\* ACCESSION NBR: 8505160389 DOC. DATE: 85/05/14 NOTARIZED: NO DOCKET #  
 \* FACIL: 50-250 Turkey Point Plant, Unit 3, Florida Power and Light C 05000250  
 50-251 Turkey Point Plant, Unit 4, Florida Power and Light C 05000251  
 AUTH. NAME AUTHOR AFFILIATION  
 WILLIAMS, J.W. Florida Power & Light Co.  
 RECIP. NAME RECIPIENT AFFILIATION  
 VARGA, S.A. Operating Reactors Branch 1

SUBJECT: Forwards info requested in NRC 850304 ltr re SPDS parameter selection. Info addresses requirements of Generic Ltr 82-33 & safety functions identified in NUREG-0737, Suppl 1. Revised schedule for SPDS implementation submitted.

Re: Turkey Point Units 3 & 4  
Docket Nos. 50-250 & 50-251  
SPDS Implementation Plan and  
Parameter Selection Report  
Request for Additional Information  
NRC TAC Nos. 51293 and 51294

## RESPONSE TO NRC REQUEST FOR ADDITIONAL INFORMATION ON THE TURKEY POINT SPDS

FIGURE 2

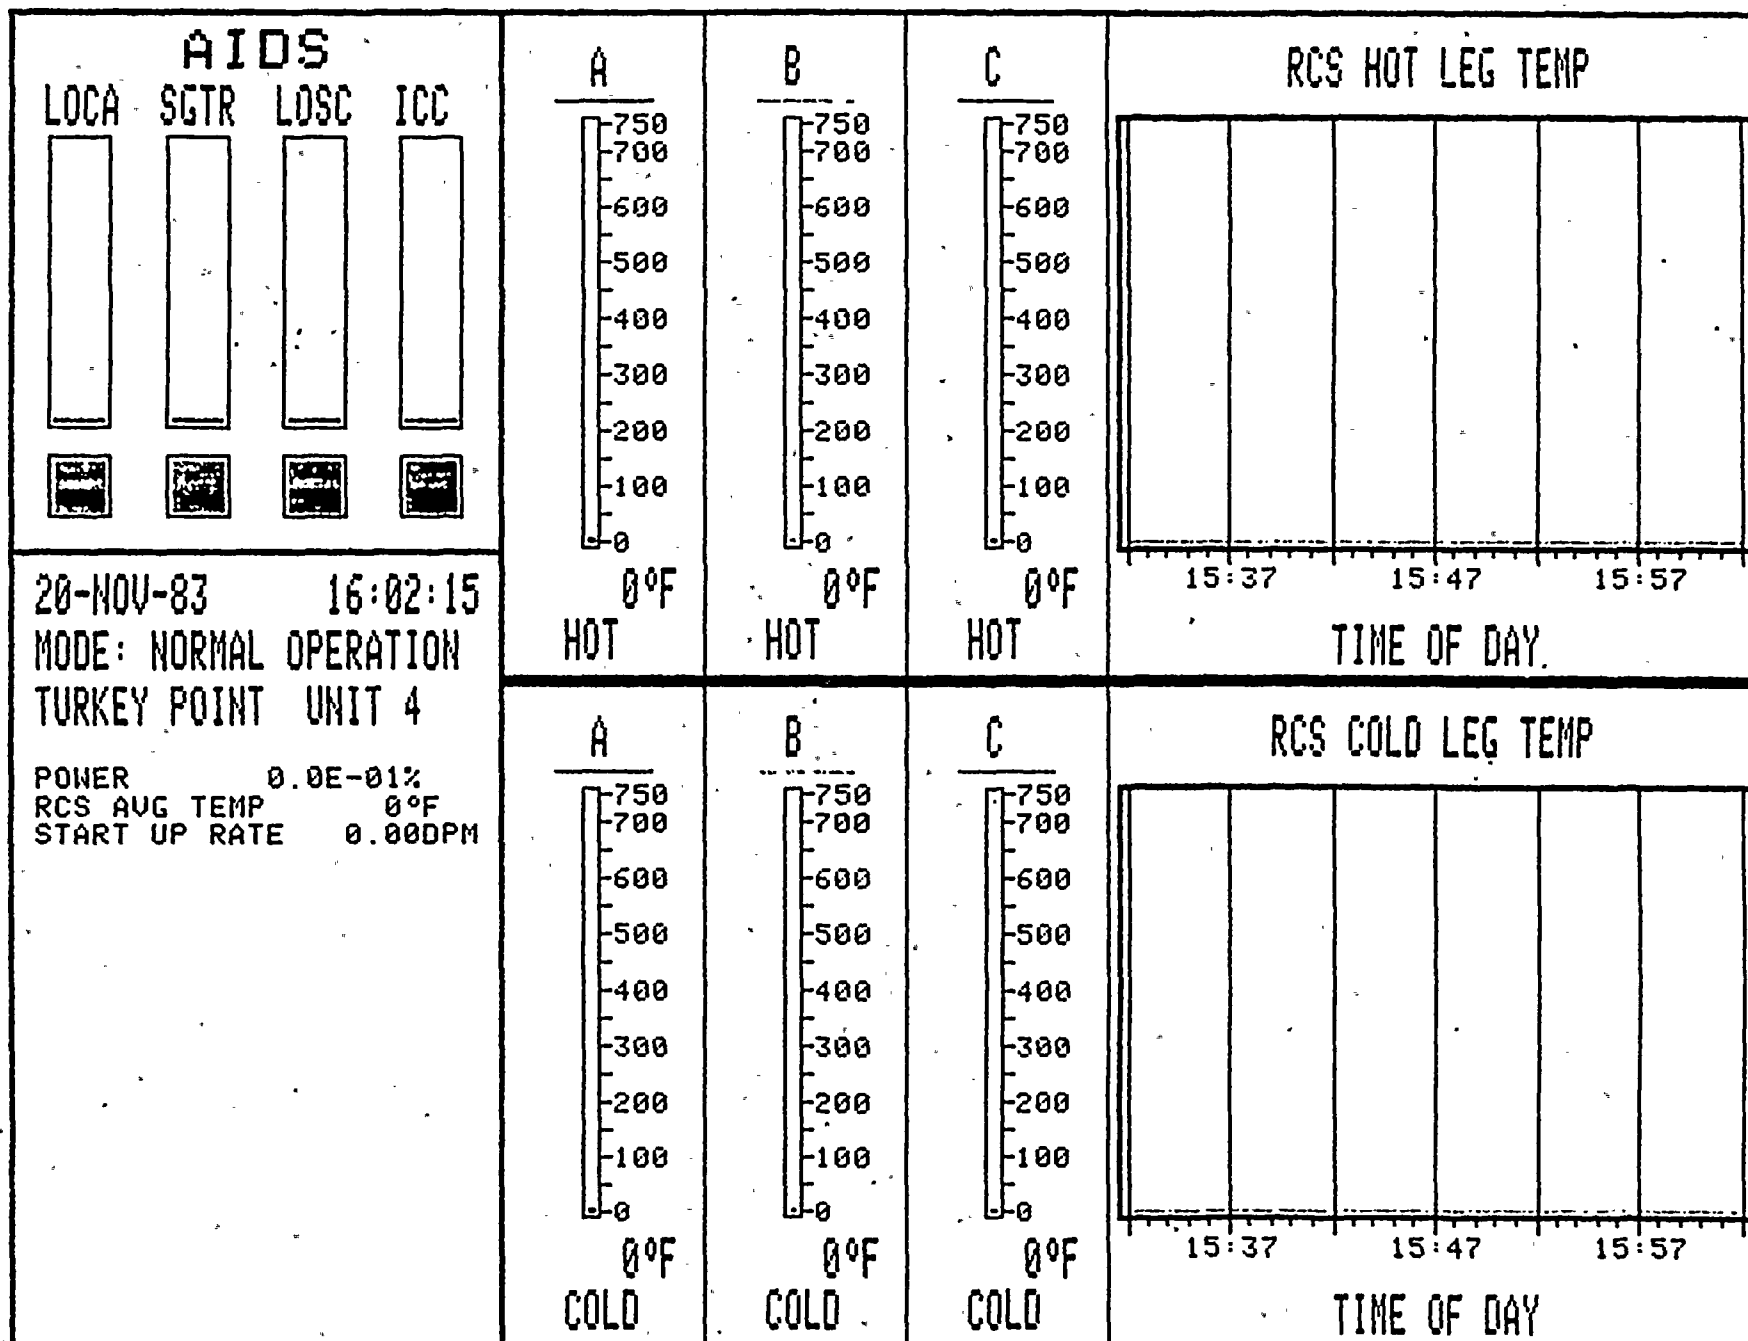
Hot leg temperature is an indicator used in the Emergency Response guidelines (ERGs) to determine the viability of natural circulation as a mode of heat removal. Core Exit Thermocouple (CET) indication is used on the Turkey Point SPDS instead of hot leg temperature as an indication of RCS temperature leaving the core. For a natural circulation event, the CET value would be essentially identical to the hot leg value. In addition, the CETs provide valuable indication of inadequate core cooling events where the core may be uncovered.

Further, hot leg temperature can be displayed on the SPDS CRT by using the dedicated function key pad located near the control board. A sample of this display is provided by Figure 2. Because this parameter was not part of our original SPDS parameter list, it will not be available on the same schedule as SPDS. Hot leg temperature will be provided to SPDS on the same schedule as SAS.

FIGURE 3

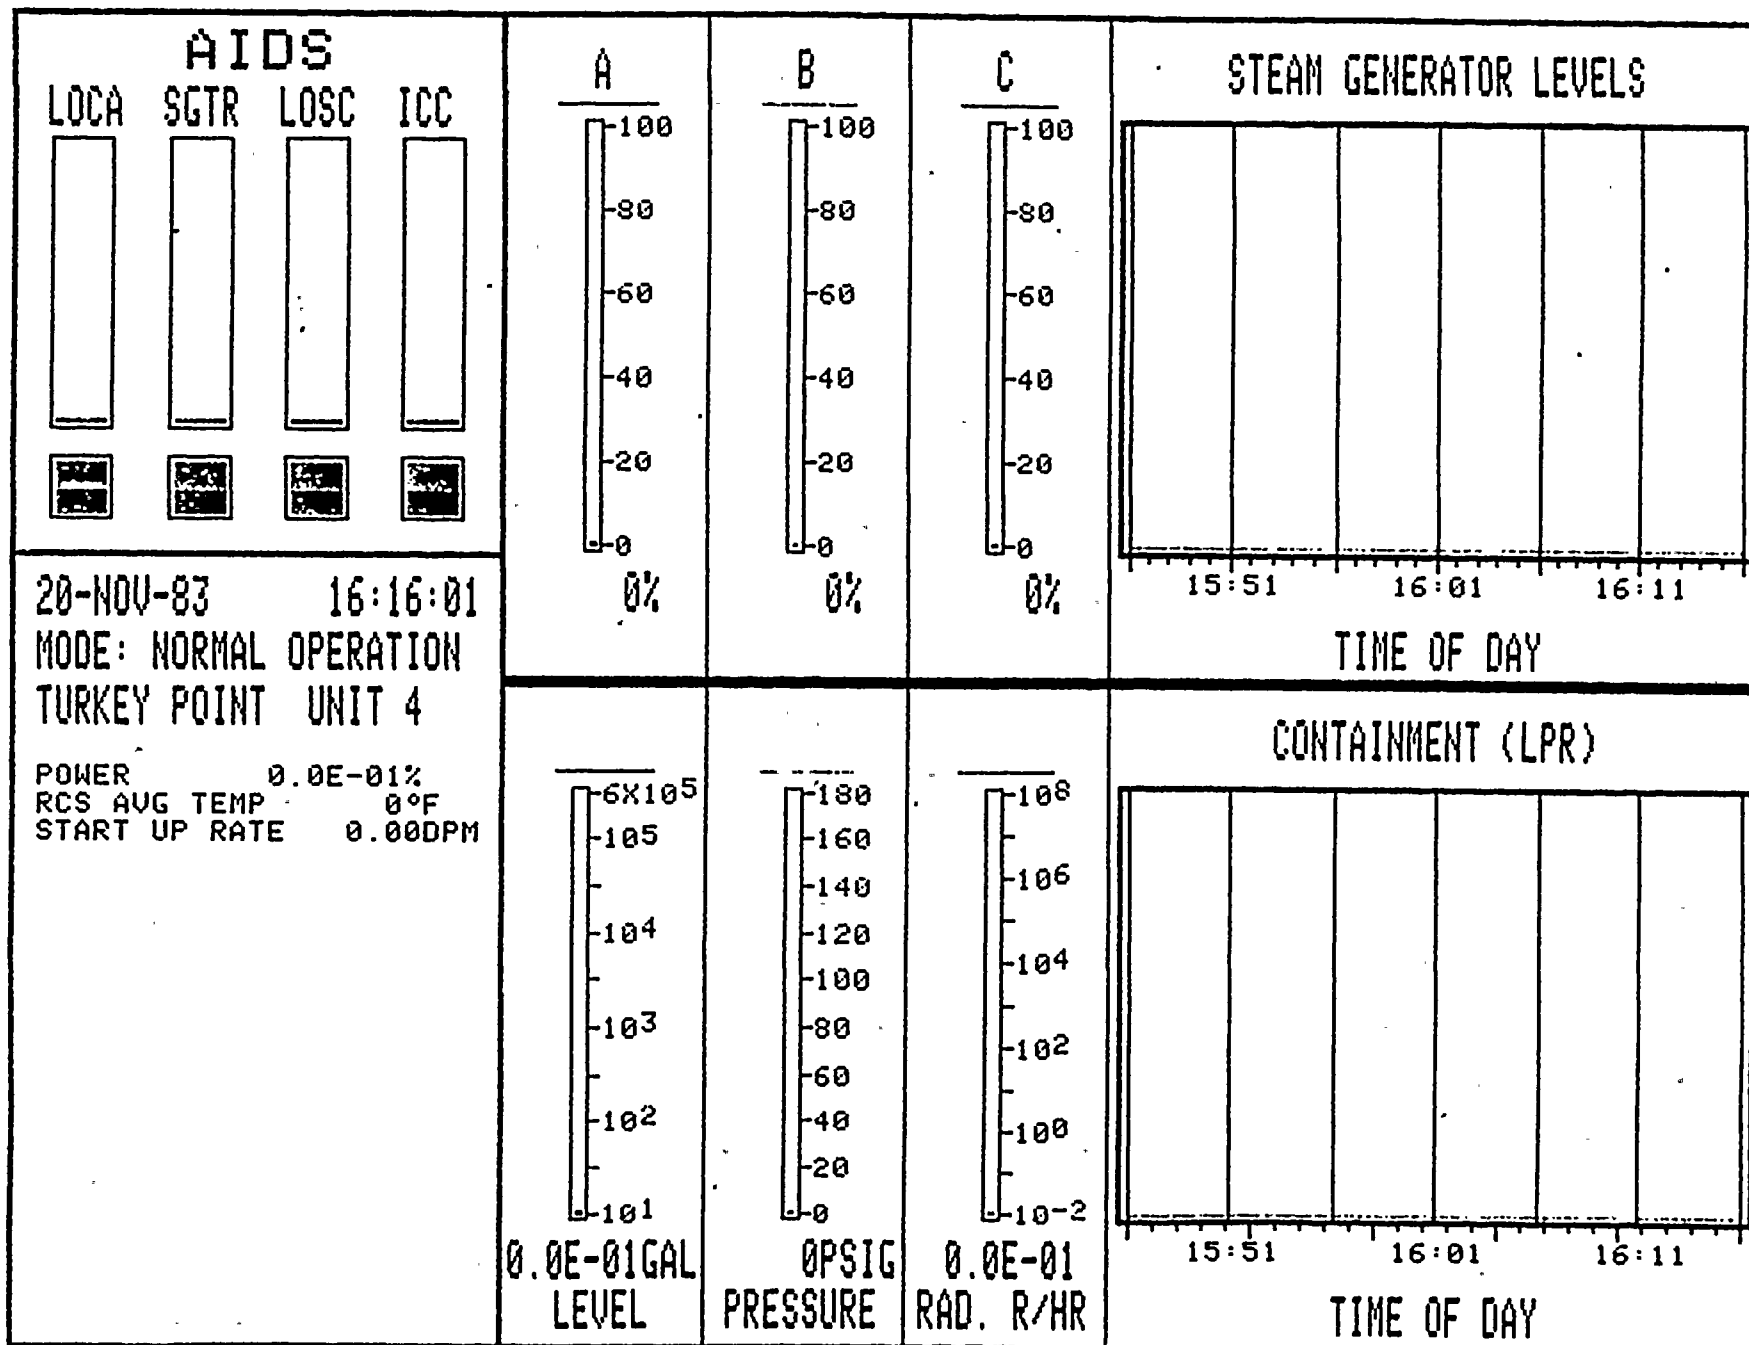
Containment sump level is one of three inputs to the containment environment target on the Turkey Point SPDS. Should any of these parameters go out of their allowable range, the containment environment target will turn red. The operator may then display each of the inputs for this target (including sump level) by use of the dedicated function keyboard located near the control board. A sample of this additional display is shown by Figure 3.

Like containment sump level described above, containment pressure is an input parameter to the containment environment target. Should containment pressure exceed set limits, the containment environment target will turn red. Precise information on containment pressure may then be shown on the SPDS through use of the dedicated SPDS key pad located near the control board. A sample of the display available for containment pressure is shown by Figure 3.
